# HORSHAM DISTRICT COUNCIL CONSULTATION

| **LOCATION:** | Land North of Horsham Old Holbrook Horsham West Sussex |
| **DESCRIPTION:** | Application for approval of Reserved Matters pursuant to Condition 5 of Outline Planning Permission reference DC/16/1677 for the extension of the Phase 1 Primary Road to Old Holbrook, landscaping, SUDS, ecological enhancements, substation, footbridge and the Sub Phase 1D Strategic Landscape Buffer.<br><br>OPP accompanied by an Environmental Statement. |
| **REFERENCE:** | DC/24/0446 |

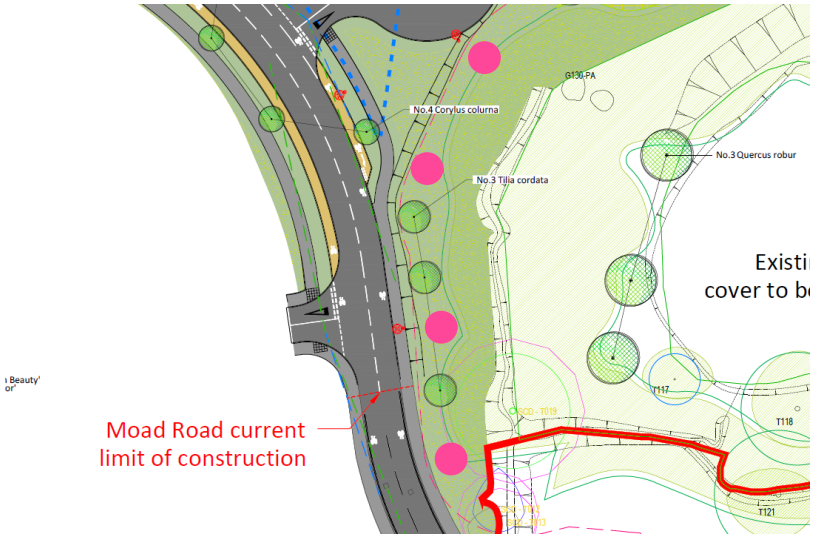
Modification is requested to secure the landscape strategy. Our chief concern is the layout of the road, cycle path and footpath which currently encroaches the minimum 15m width Ancient Woodland (AW) buffer zone. AW is classified as an irreplaceable habitat and is highly significant to both the character and the ecological function of the area. We recommend the route of the main road be altered to avoid the buffer zone in order to demonstrate the integrity and long term retention of the AW.

2. The AW buffer zone has not been clearly outlined in plan. We recommend including this detail as well as re-routing the main road, cycle path and footpath so as not to encroach the minimum 15m wide AW buffer zone as per government guidance. Addition of buffer in plan as well as re-routing of path has now been provided, with thanks.

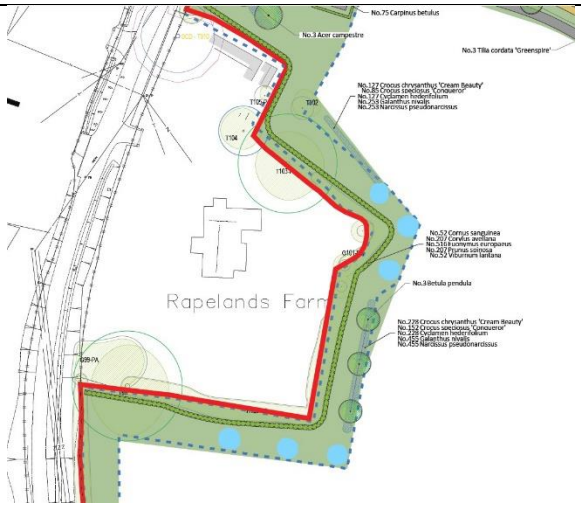
4. For tree planting adjacent to the AW buffer zone, we recommend removing Tilia cordata 'Greenspire', Corylus colurna and Acer rubrum and replacing with trees listed within the revised planting palette under DC/24/0061. This is based on guidance from the Woodland Trust which recommends creating native woodland around ancient woodland to reverse fragmentation, thereby increasing ecological connectivity to form resilient landscapes. From a landscape perspective, the trees listed above are not local features within the I2 – Warnham and Rusper Wooded Edge and K2 – Warnham and Faygate Vale Landscape Character Areas from which the proposed site is located. Recommended alternatives such as Tilia cordata and Sorbus torminalis are found within the Landscape Character Areas and are also key ancient woodland species appropriate for the buffer location. Amendment to Tilia cordata is welcomed, however proposed Quercus robur within the pond area should be removed to prevent disturbance within AW via maintenance activities, and to allow for natural regeneration. As an alternative, there is opportunity for further planting within the AW buffer zone (see indicative

areas in pink, below) to mitigate adverse effects as described in the summary of comments. Please consider key ancient woodland species such as Sorbus torminalis, as species diversity is necessary for resilient landscapes.

Not yet addressed. As previously noted, the newly proposed location requires planting and maintenance access through existing AW, thereby introducing further effects of development contributing to its deterioration and loss, which is of key landscape concern. Please relocate mitigation planting to the AW buffer, which will more likely achieve goals of maximising ecological integrity and resilience by diffusing effects from the road.
